JOB No.	2646256
DESCRIPTION	SUMMIT HOMES - WOODSIDE RIDGE #140 1ST LVL
JOB ADDRESS	TBD
CITY	LEE'S SUMMIT, MO
DESIGNER	TODD W MOORE
DATE	2/22/2021

ROOF TRUSS LAYOUT

RESIDENTIAL ENGINEERING SERVICES, LLC.
SHOP DRAWINGS/SUBMITTAL REVIEW

JOB No.	2646256
DESCRIPTION	SUMMIT HOMES - WOODSIDE RIDGE #140 2ND LVL
JOB ADDRESS	TBD
CITY	LEE'S SUMMIT, MO
DESIGNER	TODD W MOORE
DATE	2/22/2021

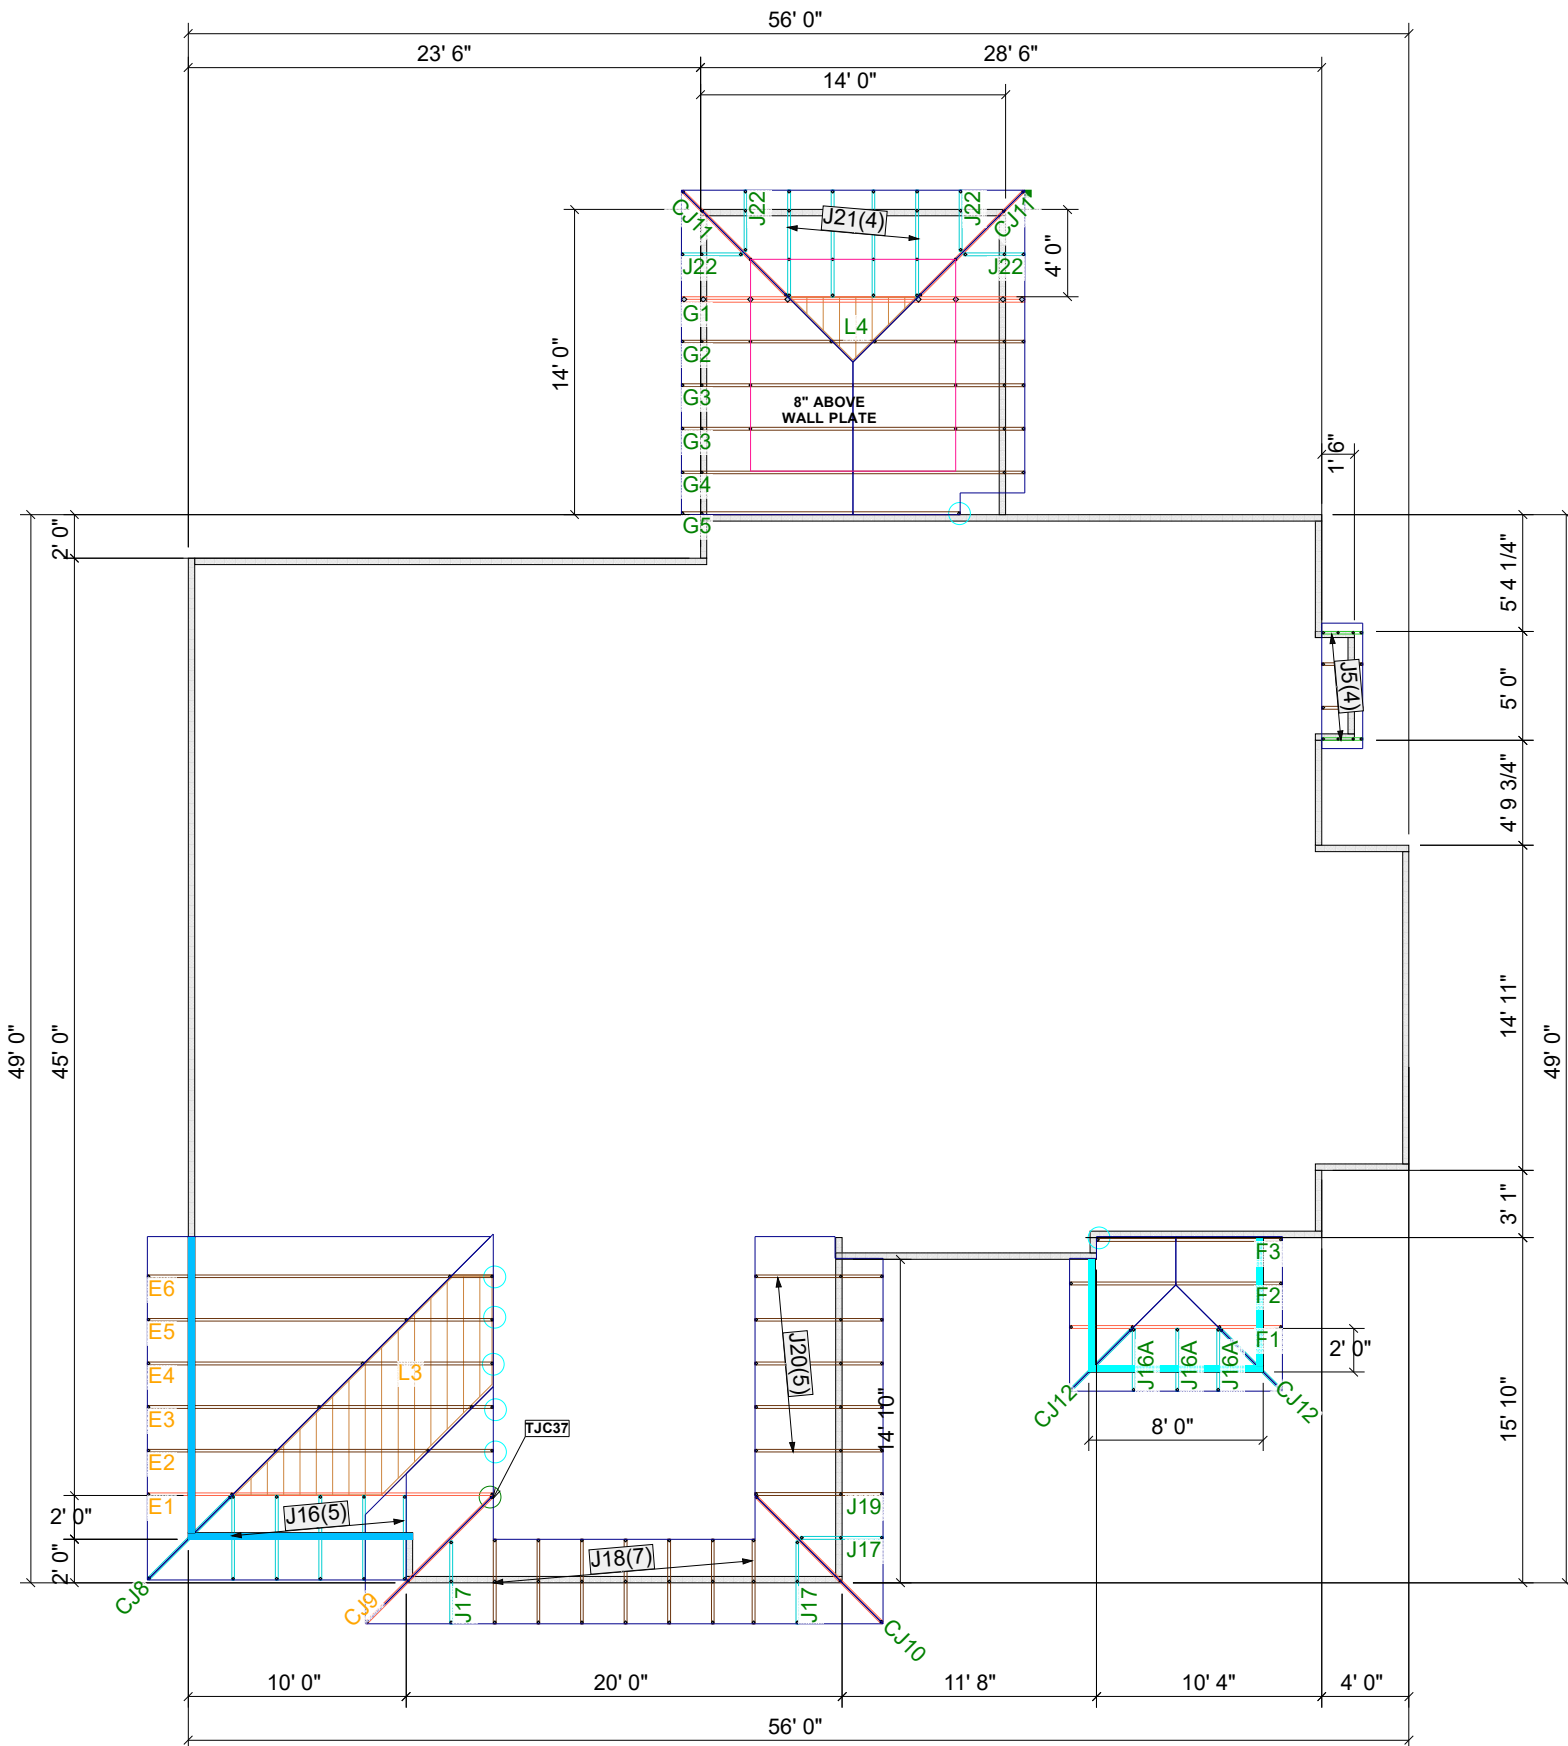
SUBMITTAL WAS REVIEWED FOR DESIGN CONFORMITY AND GENERAL CONFORMANCE TO CONTRACT DOCUMENTS ONLY. THE CONTRACTOR IS RESPONSIBLE FOR CONFIRMING AND CORRELATING DIMENSIONS AT JOBSITE FOR TOLERANCE, CLEARANCE, QUANTITIES, FABRICATION, COORDINATION OF HIS OR HER WORK WITH OTHER TRADES, AND FULL COMPLIANCE WITH CONTRACT DOCUMENTS.

STATUS:

APPROVED

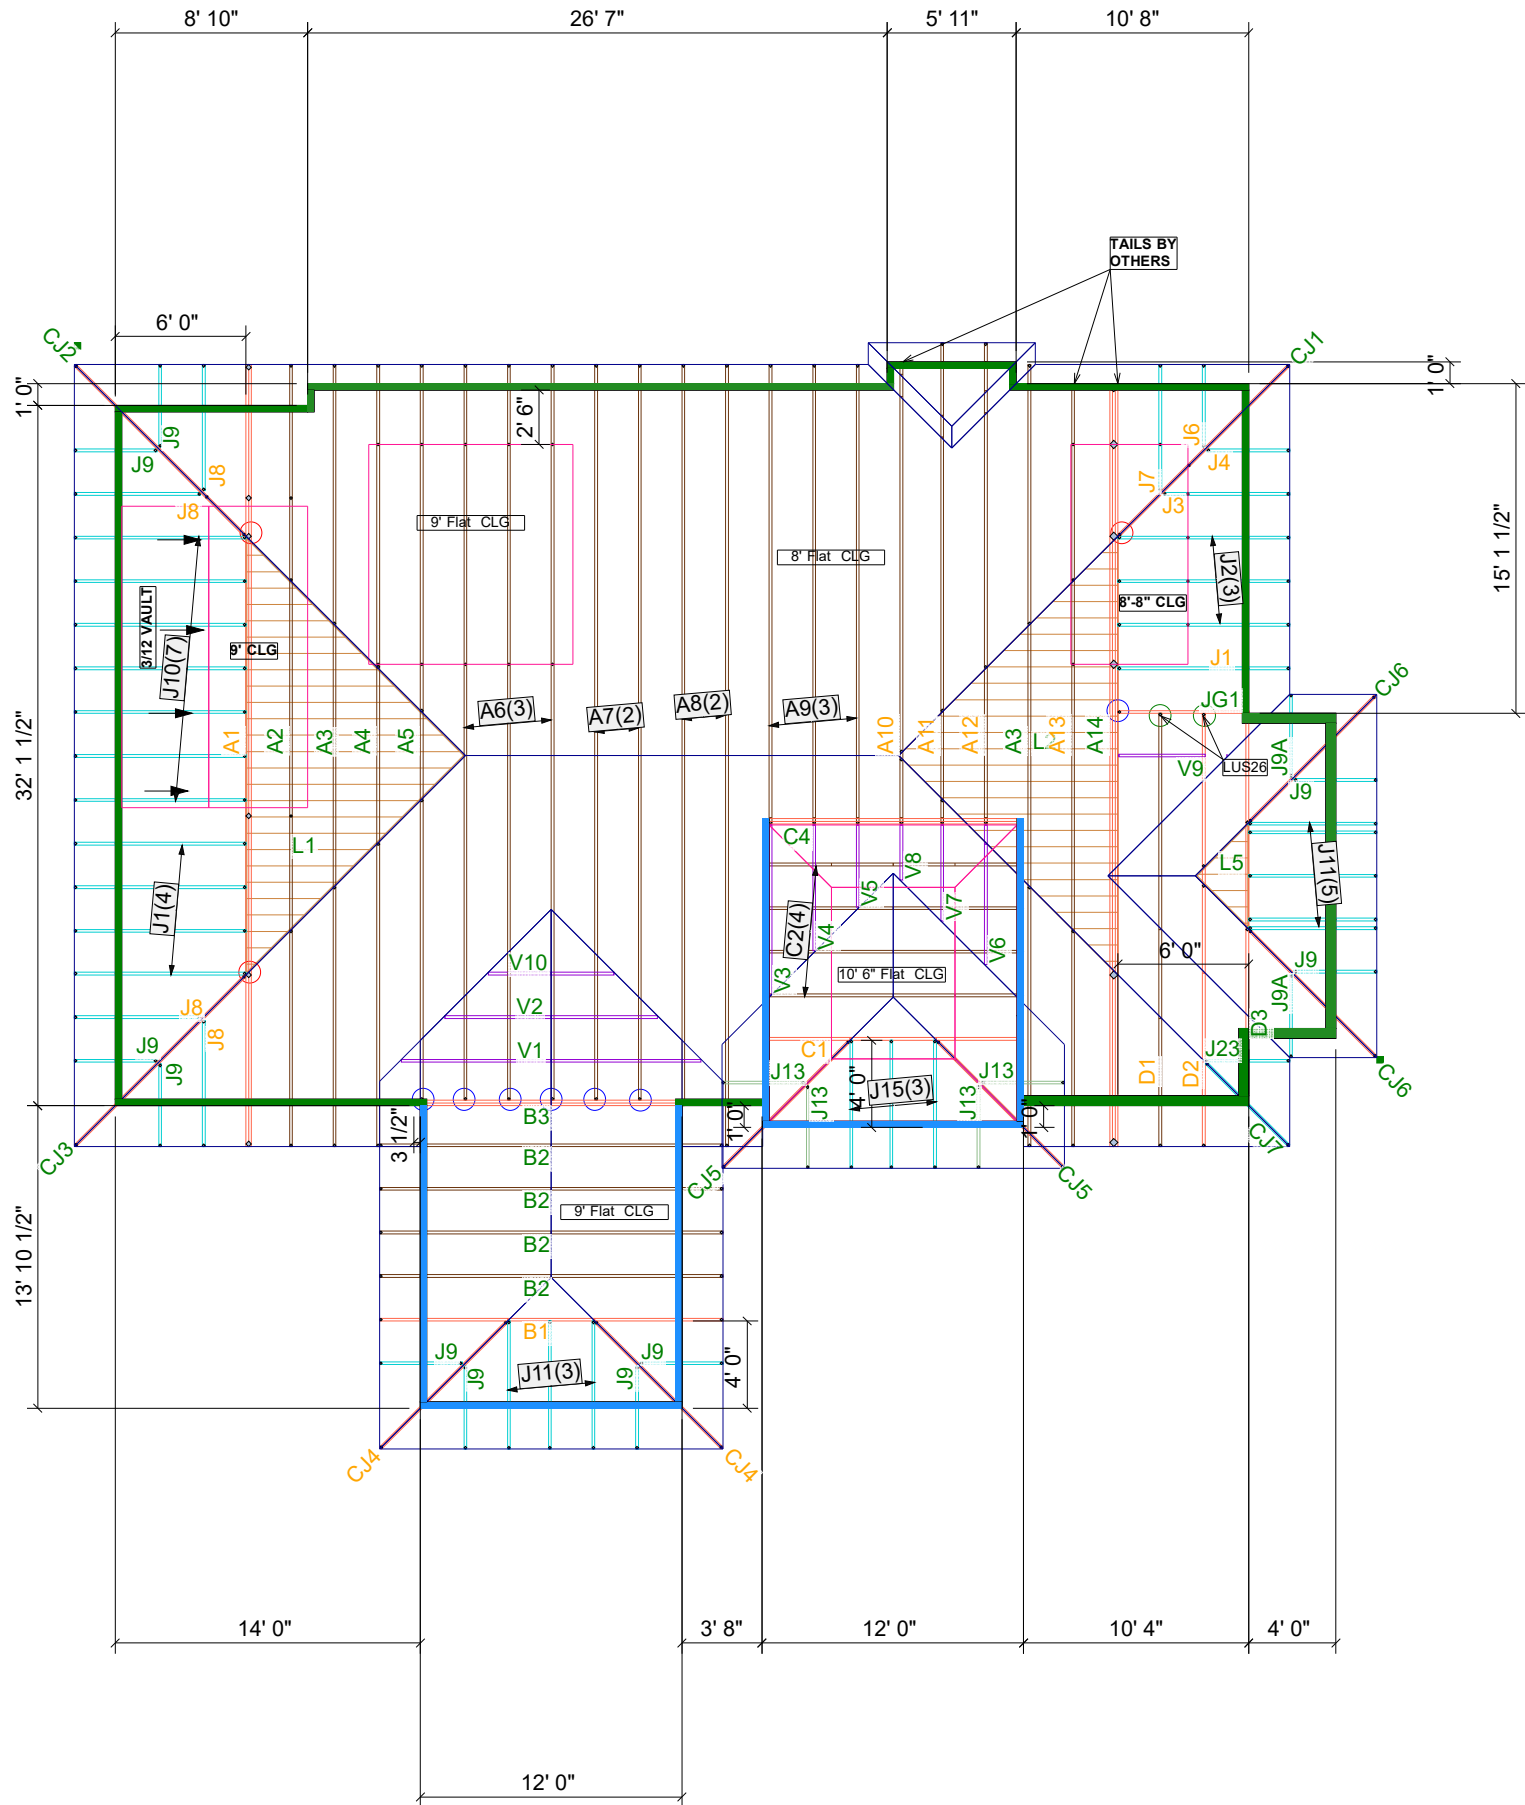
SUBMITTAL WAS REVIEWED FOR DESIGN CONFORMITY AND GENERAL CONFORMANCE TO CONTRACT DOCUMENTS ONLY. THE CONTRACTOR IS RESPONSIBLE FOR CONFIRMING AND CORRELATING DIMENSIONS AT JOBSITE FOR TOLERANCE, CLEARANCE, QUANTITIES, FABRICATION, COORDINATION OF HIS OR HER WORK WITH OTHER TRADES, AND FULL COMPLIANCE WITH CONTRACT DOCUMENTS.

STATUS:

APPROVED

**RELEASE FOR
CONSTRUCTION
AS NOTED ON PLANS REVIEW
DESIGN LOADS:
2. RACE FALL
12. PORT TCDL
LEE'S SUMMIT, MISSOURI
10. PSE BCDI**
